APPENDIX M

COMMENTS ON THE DRAFT EIR

Re: West Jackson Highway Master Plan
(State Clearinghouse No 2013092021, County Control Number PLNP2008-00240)

Subject: Draft Environmental Impact Report dated July 2024 – County DWR Drainage Comments

Exhibit A

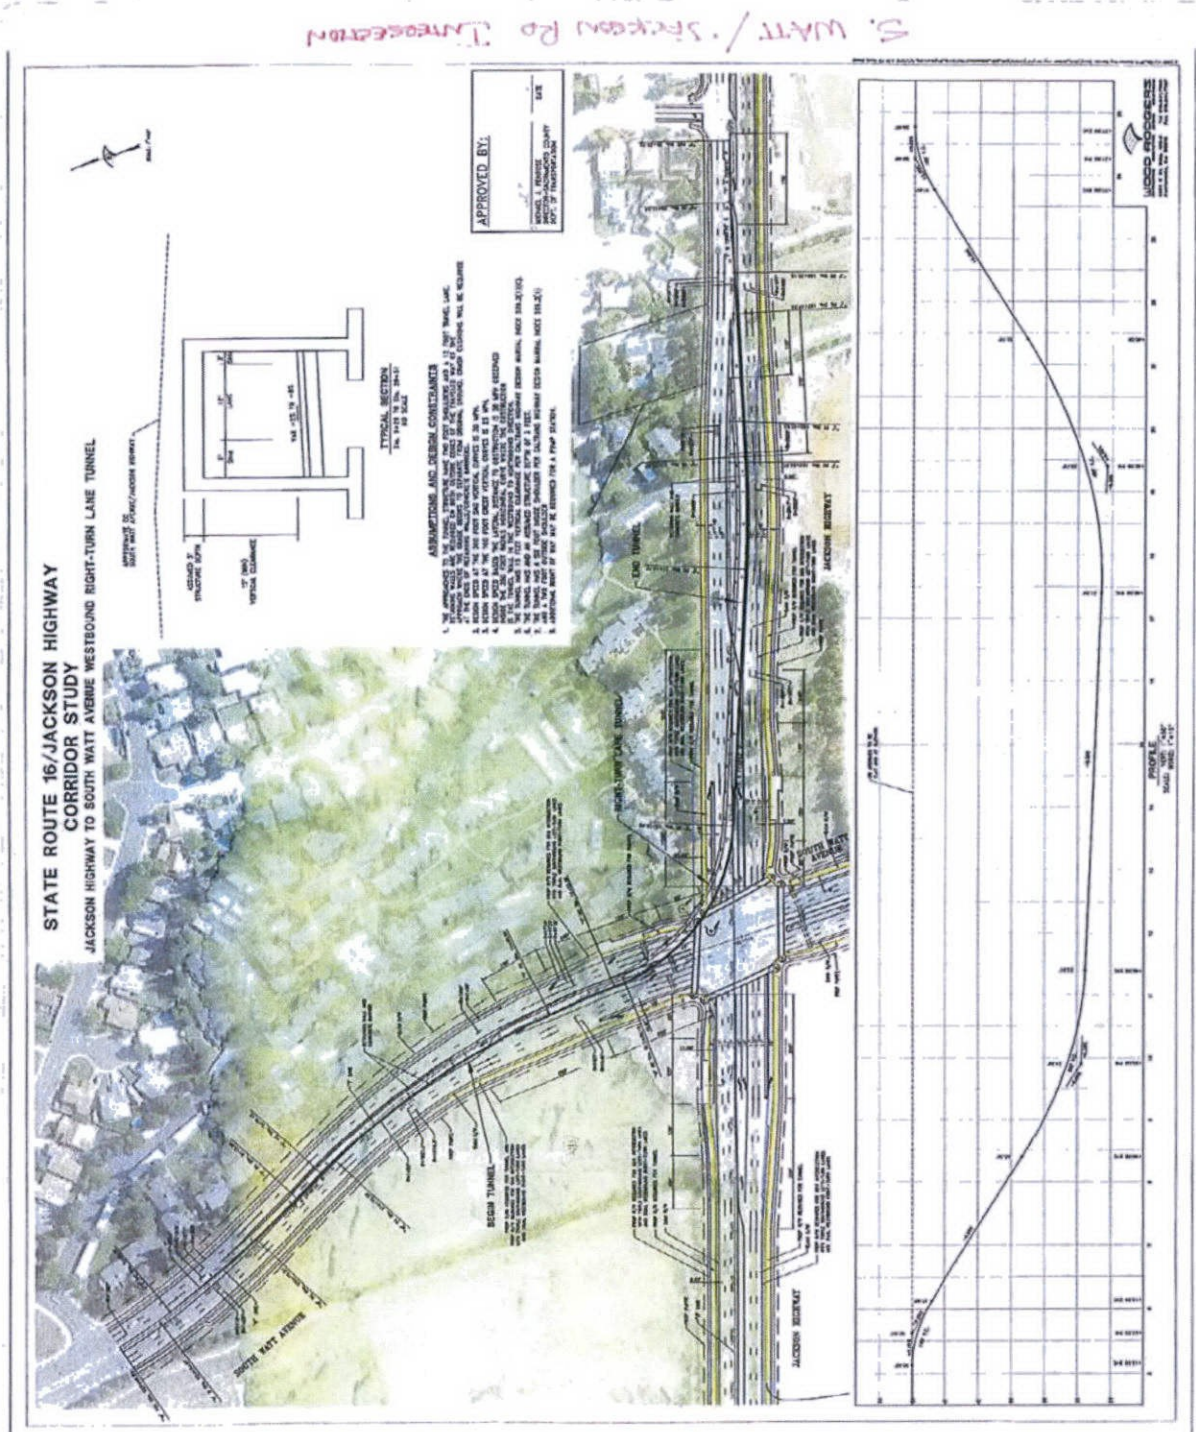
ACTC submits this comment letter and incorporates by reference its previous comment letters as they pertain to this Project. Unless this project includes the reservation of the 14 foot right-of-way as part of the design and description of the Project and within the MMRP, ACTC has no assurance that traffic will be mitigated without an enforceable implementation measure.
